PRELIMINARY SITE & LANDSCAPING PLAN
 GREENVIEW III
 GRAND JUNCTION, COLORADO

ACTIVITY Crestview Townhomes III & Revised Final Plan Crestview I

File No.: 92-81
Item: Crestview Townhomes III
Phase: Preliminary Development Plan
Location: NW of F $\frac{1}{2}$ Road and 27 $\frac{1}{2}$ Road

File No: 92-81
Item: Hawthorn Place at Crestview
Phase: Preliminary Plan

CREST VIEW TOWNHOMES

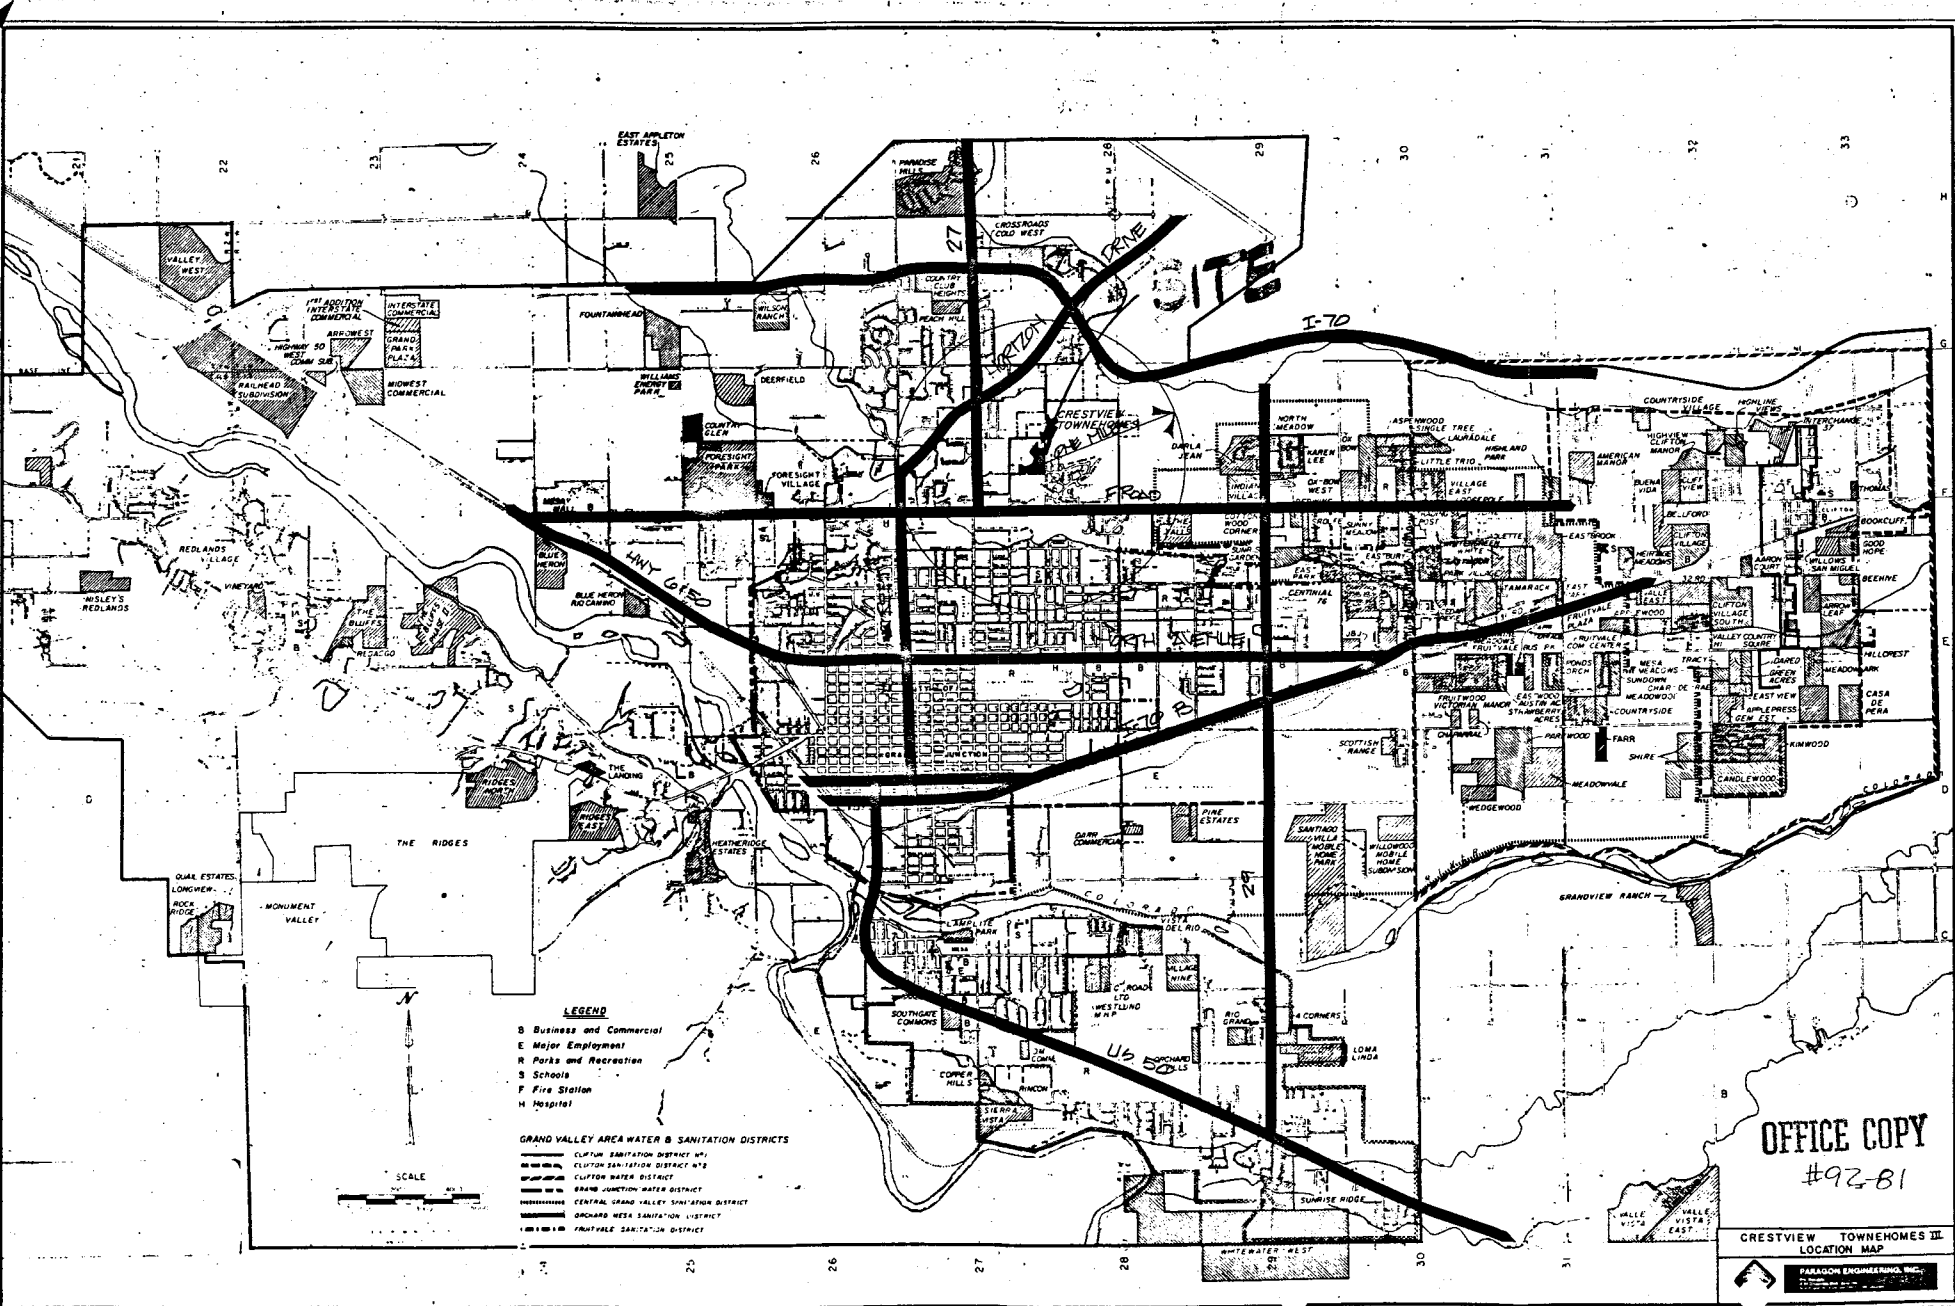
11/13/81	Transportation Engineer REVISED	The drive into the cabana should have provisions for a turn-around at the end
11/16/81	City Engineer REVISED SIC	20 Ft. radii should be provided on all corners of streets rights-of-way. 20 ft. wide easements centered on the pipes should be provided along all sanitary and storm sewers outside of streets rights-of-way. A power-of-attorney should be provided for street improvements on 27½ Road or preferably the improvements constructed in accordance with my November 3, 1981, letter to Paragon Engineering concerning this matter. A subdivision improvements agreement in proper form should be submitted. A financial guarantee in accordance with Development Regulations Section 27-2.3 should be obtained for all public improvements. Detail construction plans for all public improvements should be submitted for my approval prior to construction. Hawthorne Avenue should have a gravel street thru to 27½ Road (15th St.) or a 40 ft. radius gravel cul-de-sac. The gravel improvements and required rights-of-way should be provided by the petitioner. Who will maintain those "waterscapes"? The petitioner should construct the required sanitary sewer to 15th Street and provided necessary right-of-way. All other previous review comments except those aforementioned have been addressed on the plans received November 6, 1981.

12/15/81	Staff Comments	<ol style="list-style-type: none"> 1) Setbacks of principal structures are not indicated on the final plan, but are indicated on the revised plan. Does revised plan setback apply to the final? 2) Trash pick-up needs to be coordinated with Bill Reeves. 3) Private drives should provide adequate turn around. 4) 5% open space fee paid prior to recording of plat. (Sec. 5-4). 5) Need power of attorney for 27½ Rd. 6) Need copy of covenants. 7) Dimensions of covered parking needed. 8) Will there be any on Street parking on private drives? May want to place "no parking" signs if not. 9) Min. parking stall is 18'5" with no overhang allowed. Shown as 18' on plan. 10) On building envelopes, is it 4 plexes shown for area south of Woodlake Pl.? 11) On final - what is the total number of parking spaces? Will they be designated for specific units? <p>Project must obtain building permit within 1 year of final approval or be scheduled for a rehearing.</p>

<u>Agency</u>	<u>Response</u>
Ute Water	Ute water's comments were information in nature and will be incorporated with the preparation of the Final Development Plan.
Transportation Engineer	1) The entrances to the two private drives paralleling 27 $\frac{1}{2}$ Road will be relocated further west along the adjacent dedicated roadways. 2) The south access point to the parking area just east of the dedicated 30' right-of-way will be closed. Access to the aforementioned parking will be from the proposed dedicated 30' right-of-way as shown.
City Fire Department	The Fire Department comments were informational in nature and will be incorporated with the submission of the Final Development Plan including the additional hydrant as requested.
Mountain Bell	All requested easements required by Mountain Bell will be provided on the Final Plat.
City Parks and Recreation	Had no comment.
City Police Department	Parking lot security lighting as well as walk lighting will be provided for throughout the entire Crestview III development.

City Engineer	1) A new subdivision improvements agreement and City format will be provided with the Final Plan and Plat. 2) A 20' wide easement will be provided on the submitted Final Plat for all sanitary sewers located outside of dedicated streets. 3) A 10' radius will be provided at all street corners.

- a) Setbacks as shown on the revised plans do apply to the final.
- b) Trash pick-up will be coordinated with Bill Reeves.
- c) Private drives - See comments above for City Engineer and City Fire Department.
